STAFF REPORT

SUBJECT: H-2022-0030 – Overland & Wells II –
MDA, CUP, ALT

LOCATION: 2600 E. Overland Rd., in the SE ¼ of
Section 17, Township 3N., Range 1E.
(Parcel #S1117438626)

C. Proposed Landscape Plan, Site Amenity Plan & Site Data (date: 4/27/2022)

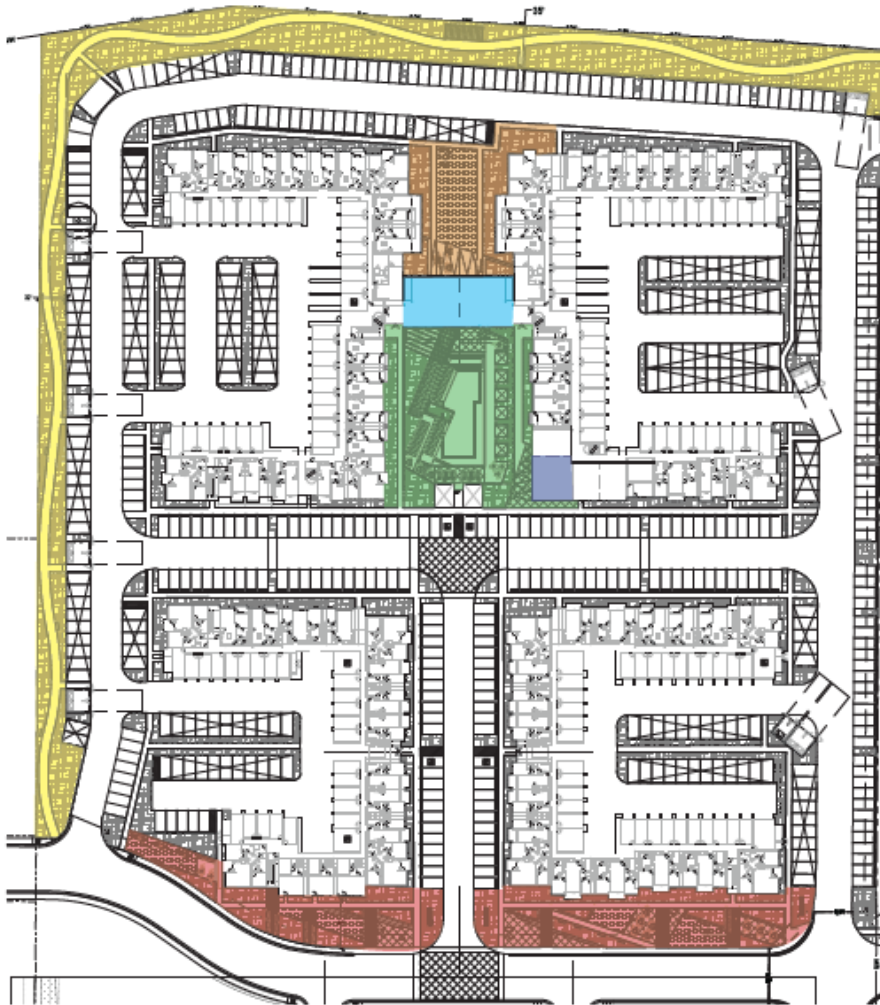
- a. Buildings shall provide a minimum setback of ten feet (10') unless a greater setback is otherwise required, per UDC [11-4-3-27B.1](#). *The garage structures along the eastern boundary don't comply with this standard.*

- f. Include details for the proposed amenities (i.e. grills & fire pits, public art, shade structures, etc.).
 - g. Widen the buffer along the west boundary of the site to include a minimum of 5-feet outside of the sewer easement to plant trees in accord with the standards for perimeter parking lot landscaping in UDC [11-3B-8C](#) and landscaping along pathways in UDC [11-3B-12C](#); or, apply for alternative compliance to these standards as set forth in UDC [11-5B-5](#). (Note: If wheel stops are not proposed to be provided within abutting parking spaces, an additional 2-feet is required to be added to the adjacent buffer to allow for vehicle overhang per UDC 11-3C-5B; the length of parking spaces may be reduced by 2-feet to 17-feet if 2-feet is added to the buffer width.) A 14-foot wide maintenance road should be depicted within the easement and any landscaping within the area where the maintenance road is located should be removed from the plan; the 6-foot wide area within the easement outside of the maintenance road area may be landscaped with grass and bushes.
